TOWN OF PARADISE VALLEY

Kachina Estates Subdivision Sign & Modified
Subdivision Wall (MI-17-02)

Town Council
October 12, 2017

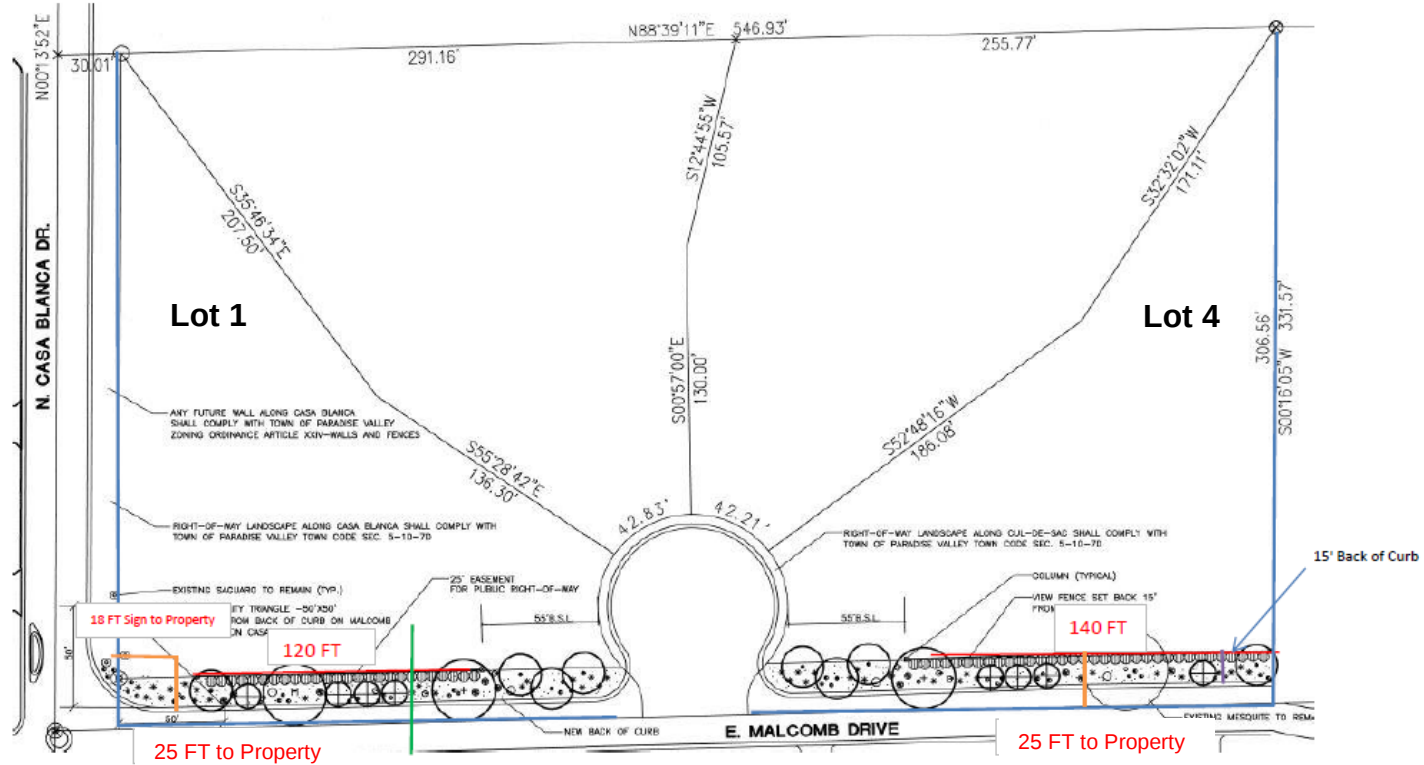
- Comparison with Article 25 of Zoning Ordinance:

CRITERIA	PROPOSED WALLSIGN
Quantity: 2	1
Content: Name & Logo	Name
Sign Area: 8 sf	12.4 square feet
Height: 3 feet (36")	3.9' (47")
Setback: 25 feet	18' from Casa Blanca Dr. 25' from Malcomb Dr.
No audible signs permitted	Sign will not have any components that flash, move, or are otherwise animated/audible
Indirect lighting of sign limited to two 75-watt incandescent bulbs (750 lumens) per sign side; bulb completely shielded from view at nearest property line, limited to 0.75 foot-candles at property line	No Illumination

SITE PLAN

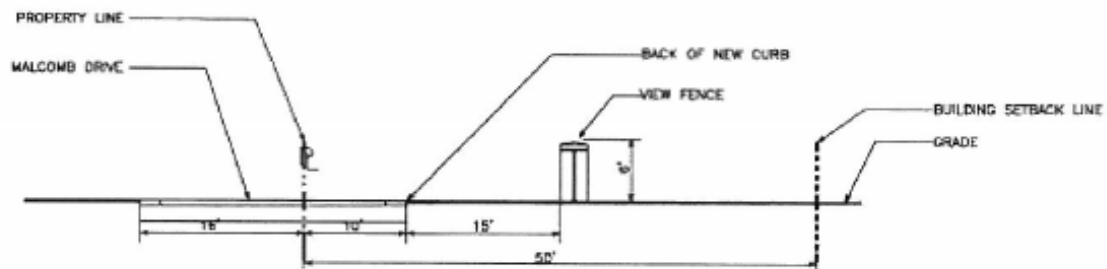
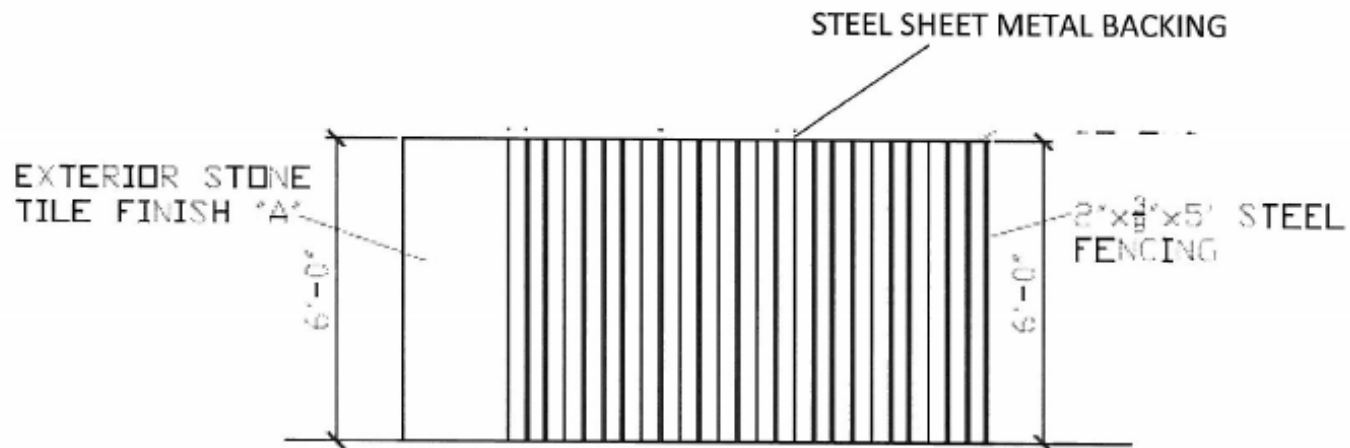
- Staff supportive of sign:
 - Sign not illuminated and only one sign
- Staff not supportive of fence wall screening:
 - Does not meet intent of original Council approval
 - Originally approved with 25' roadway easement (in lieu of ROW dedication)
 - Approved with view fence in order to preserve and maintain visual openness
 - Screening eliminates visual openness and increases presence or massing of fence

- Staff recommends approval of sign and denial of adding fence screens
- Should Council wish to approve application, sign and fence screens shall be in substantial compliance with plans and docs
